Access Compliance Report Public Rights-of-Way (Curb Ramps)

Intersection ID: 46810 Main Street: ARBOR VISTA DR Cross Street: CLAUDE FREEMAN DR Location: **ADA ID: BE1AA4FCC3E4** Ramp Type: Combination1 Initial Pass/Fail: Fail **Overall Compliance: No** Severity Score: 33.75

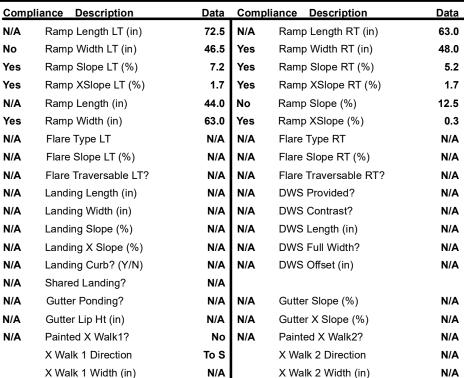
Street 1 Name YieldSign Stop Condition-Street 1 ARBOR VISTA DR N/A Street 2 Name Stop Condition-Street 2 N/A Possible Solutions: Remove & Replace Entire Ramp. Surveyor Notes: N/A PROW/ADA: R304.5.1, R304.2.2
